Groundwater Application Review Summary Form

Application # G- 19354

GW Reviewer Gabriela Ferreira / Dennis Orlowski Date Review Completed: August 4, 2023

**Application G-19354 Hope Village
T4S, R1E, Section 4**

Water-Level Measurements in Nearby Wells

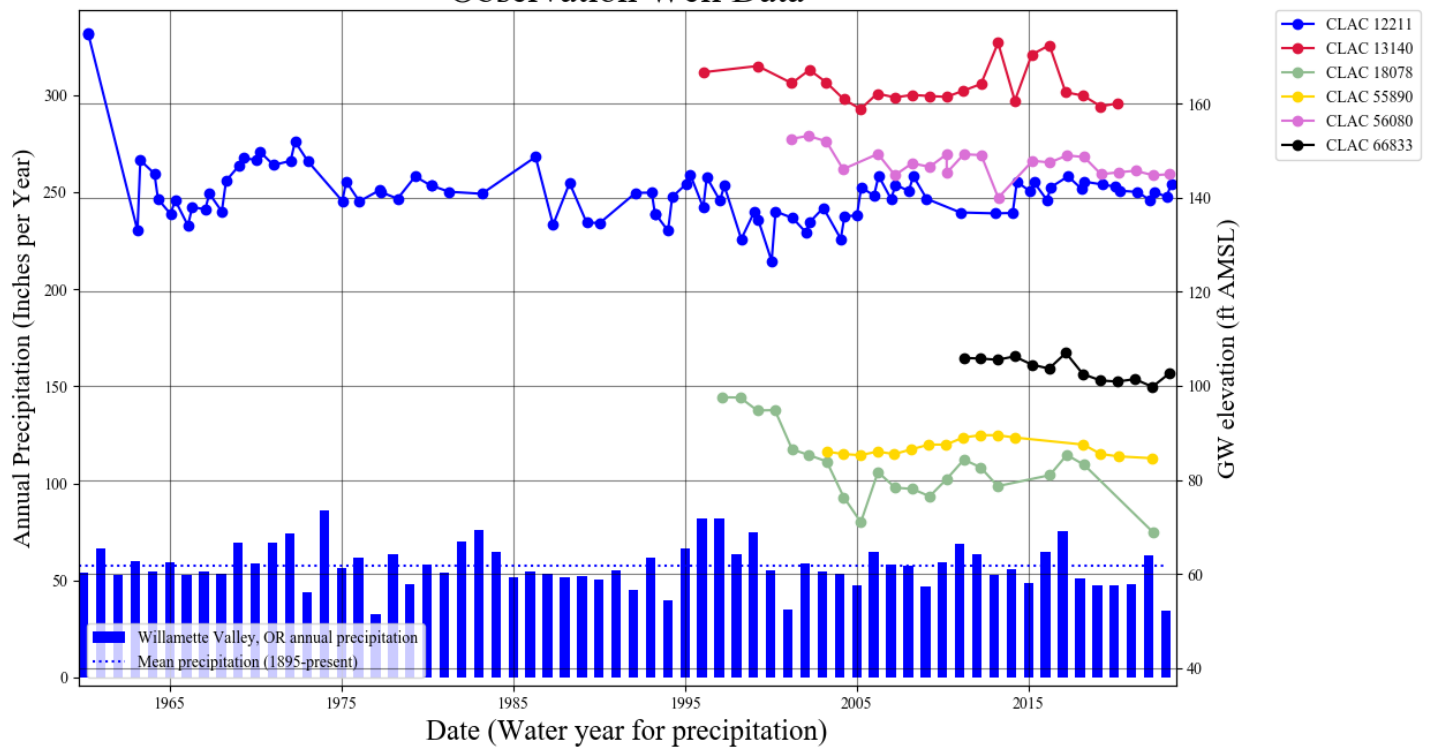
Six wells with sufficient water level data for evaluation and similar in construction to the proposed POAs were identified within approximately 2 miles of the proposed POAs, ranging in total depth from 163 to 346 feet bls. Reported water level elevations for these wells range from about 80 feet above mean sea level (amsl) to 160 feet amsl. Water level data shows some variability between 10 to 20 feet over the past 30 years, which appear somewhat correspondent to precipitation (e.g. CLAC 18078). CLAC 12211 is constructed at a shallower interval than the proposed POAs but has a data record beginning in

1960 and shows overall stable water levels with approximately 20 feet of variability over the years. Overall, representative water level data appears generally stable with no apparent or significant declines.

No nearby wells fully penetrate the 600-800 ft deep Willamette Aquifer system in this area, and thus potential injury to nearby groundwater users was not assessed for this review. However, permit condition 7N is recommended to assess potential future injury concerns, and as a means to monitor long-term groundwater conditions in this area.
